SITE: NISA		Building 3400 Avenue 3000 Cork Airport Business Park, Cork T12 AE76				STATUS: PLANNING	
TITLE: Proposed Project Option 2 WTG and Jacket Foundation						REV: A	DESCRIPTION: Issue for Approval
SCALE AT A1: 1:1000	DATE: 10/02/2026	DRAWN: EG	CHECKED: JDUB	Approved: MJ	C	DESCRIPTION: Planning Issue	DATE: 12/4/24
					D	DESCRIPTION: Planning Issue RFI	DATE: 10/2/26
					Drawing No: 281240-NISA-OFS-OA-DR-PL-2003

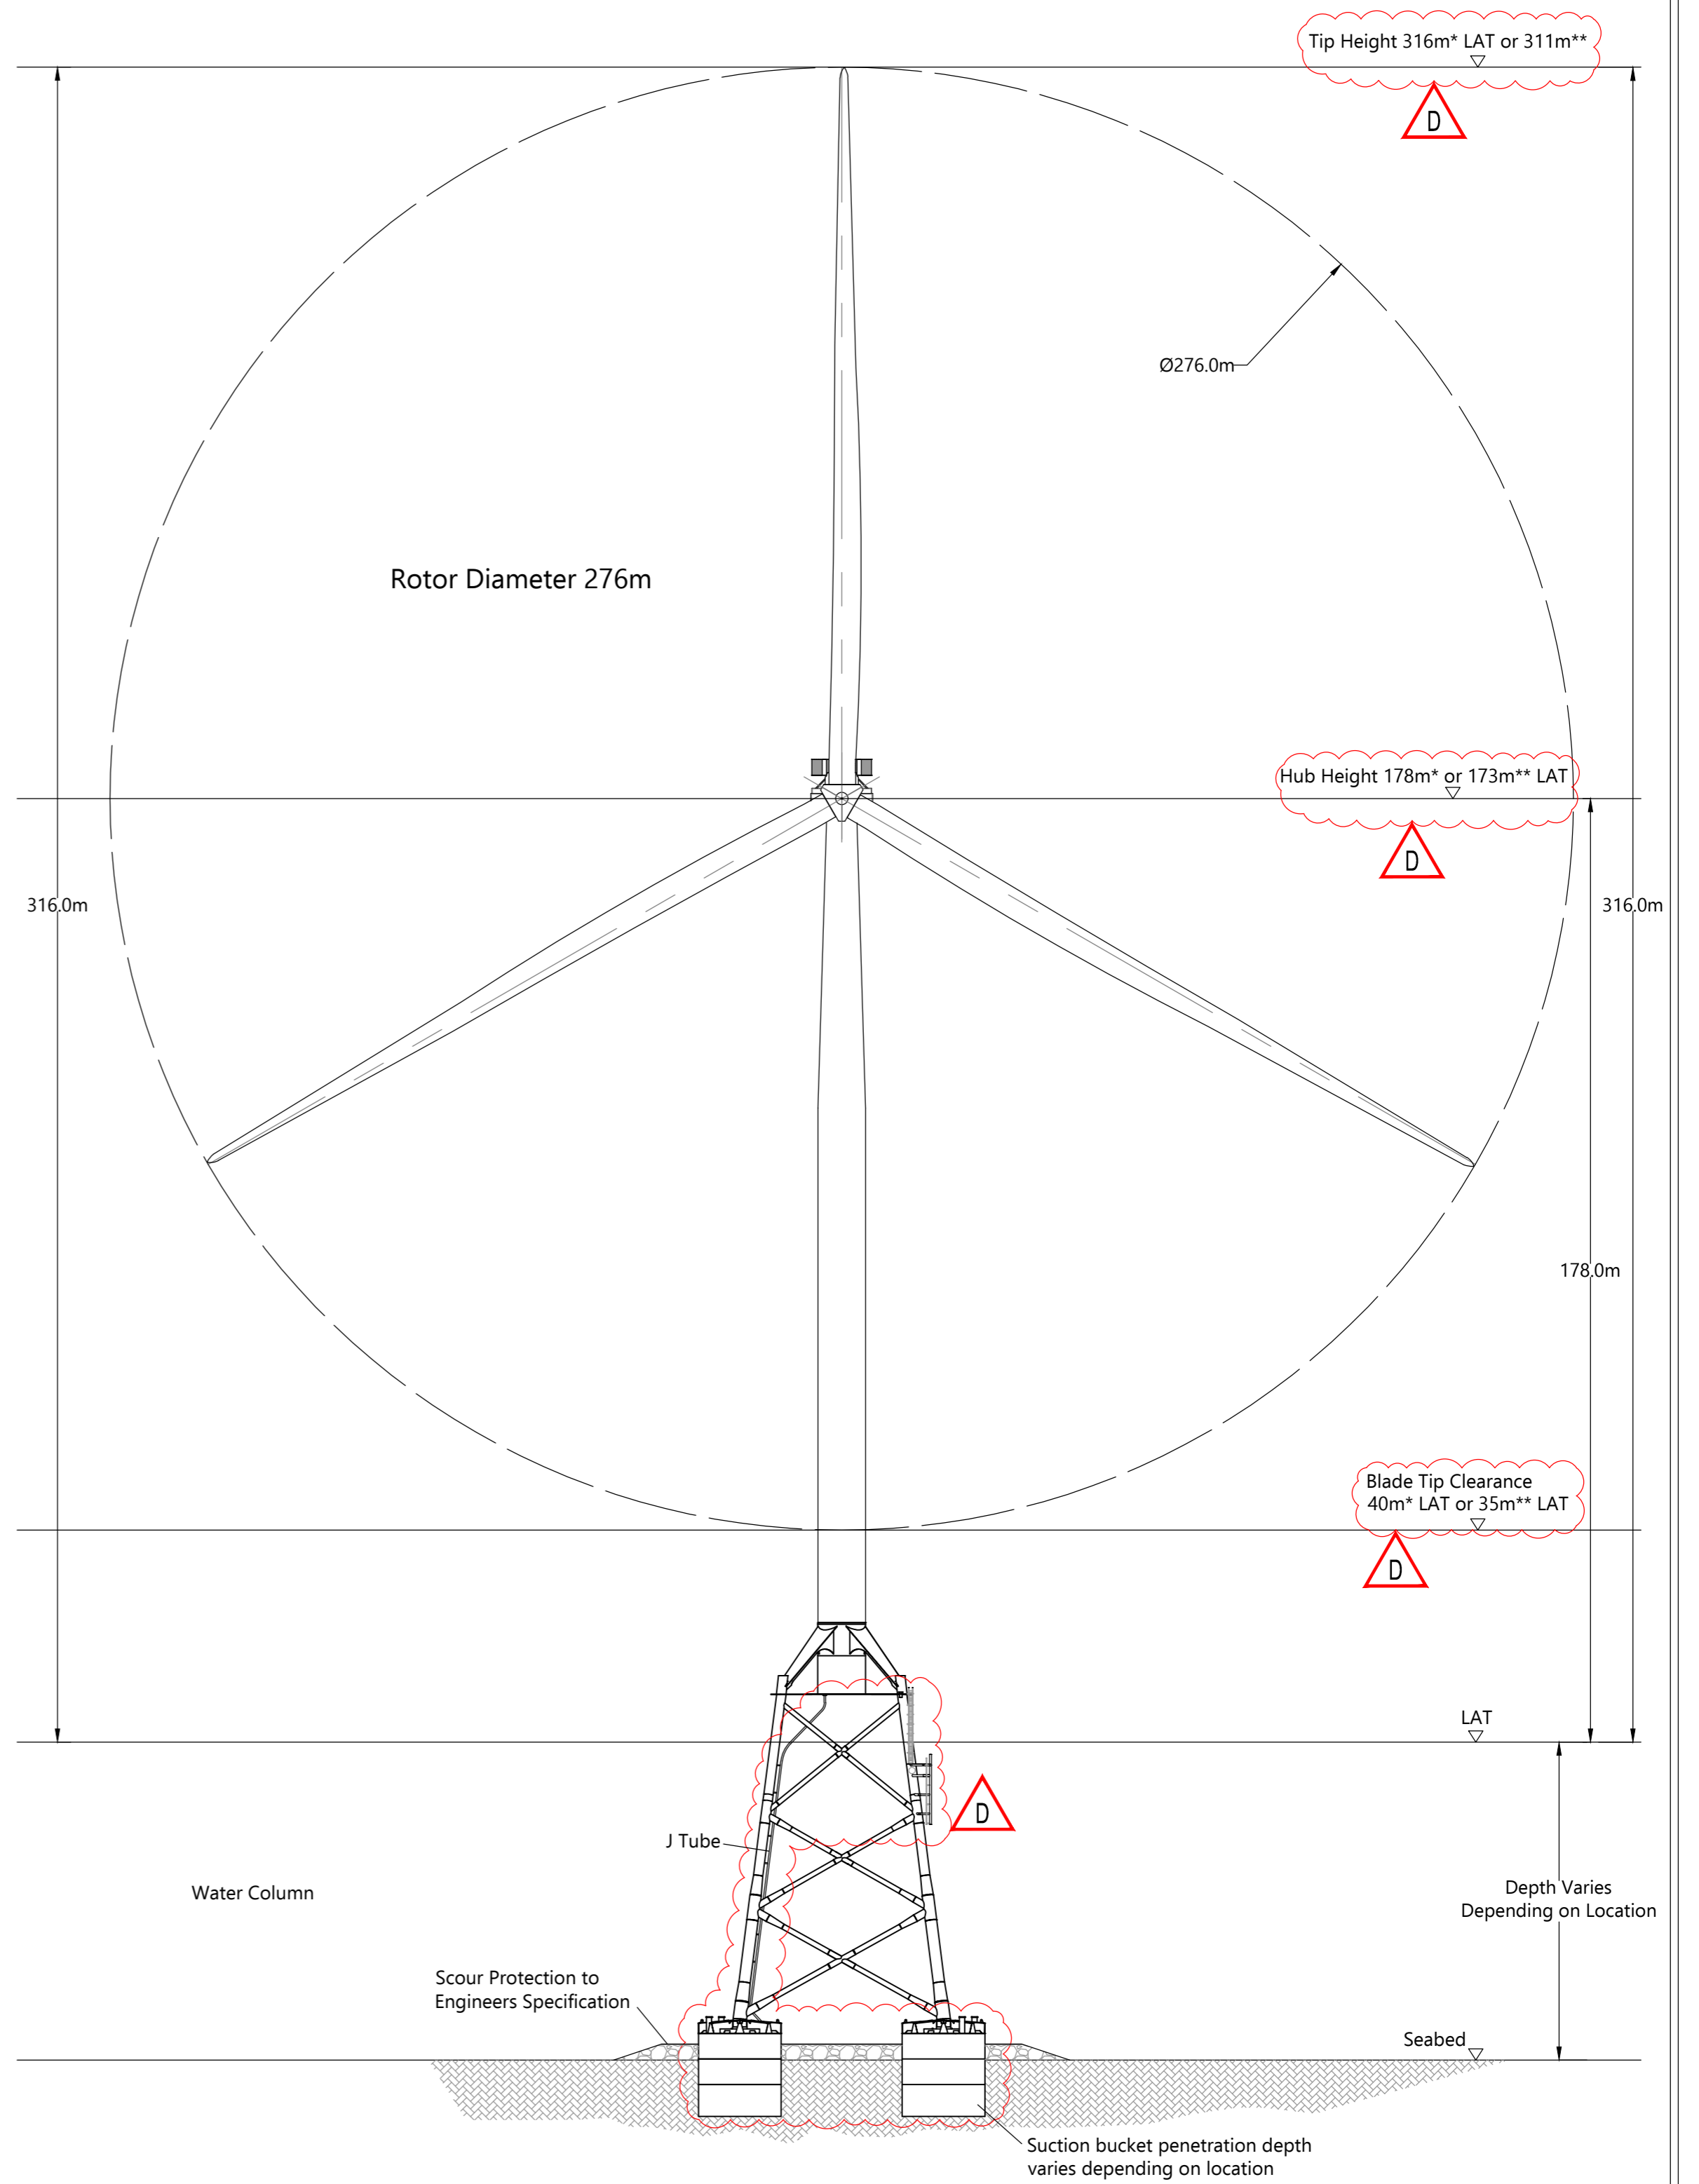
In response to Section 10 (a) of the RFI the Developer has proposed a refinement to the foundation types used for the wind turbine generators (WTGs) and offshore substation platform (OSP). Instead of either monopiles or jackets, only jackets will be used. Additionally, instead of installation with pin piles the jackets will be installed with suction buckets only for WTGs, and either jackets with suction buckets or jackets with drilled pin piles will be used for the OSP.

The Developer notes an administrative error in the planning drawings submitted alongside the 2024 EIAR that did not include the J-tube in the elevation drawings for the jacket foundations. This has now been included to illustrate where the array cables will connect the WTG and OSP to the seafloor.
